## SERVICE BULLETIN

ENGINE - LP COMPRESSOR - PROVIDE A NEW FAN FRAME ASSEMBLY AND ELIMINATE A T2.5CM THERMOCOUPLE - CATEGORY CODE 7 - MOD.ENG-72-0211

# V2500-ENG-72-0211

Modification of the thermocouple  
Fig.1

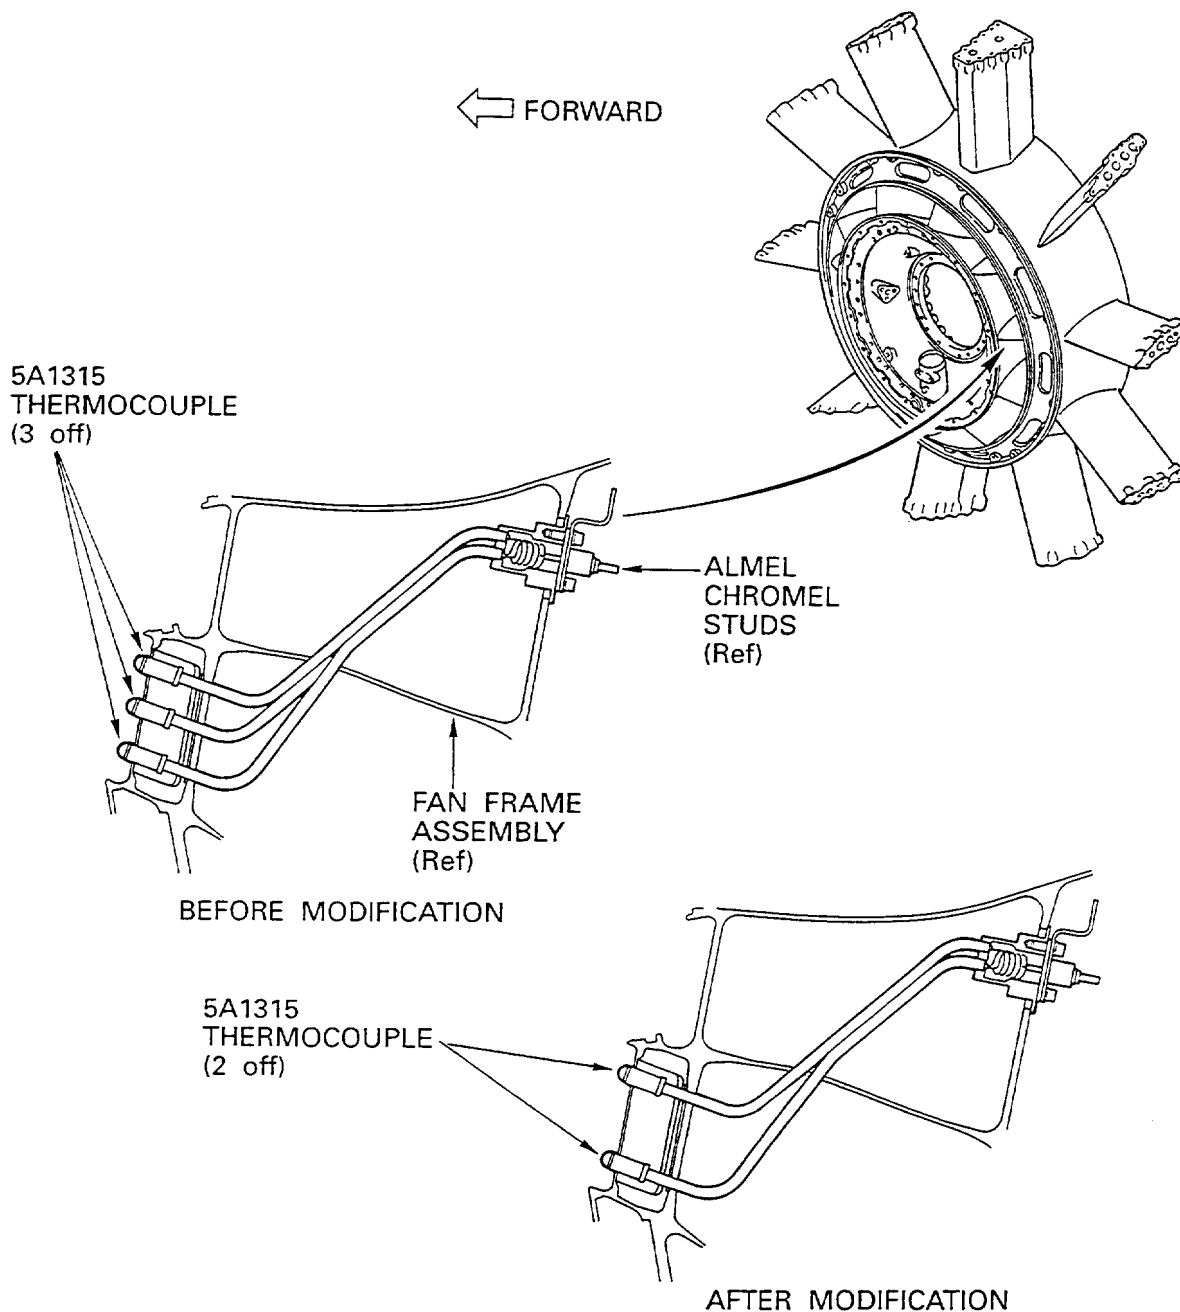
To reduce quantity of T2.5 CM thermocouples from three to two and replace the Front Bearing Compartment (FBC) rear buffer chamber seal drain tube with flow-restricting pin that is installed into the internal of the fan frame assembly.

- (1) The changes introduced by this Service Bulletin are as follows;
  - (a) to reduce quantity of T2.5CM thermocouples from three to two (See Figure 1).
  - (b) To eliminate the seal drain tube and modify the oil drain passage of fan frame assembly to restrict drain oil flow (See Figure 2).
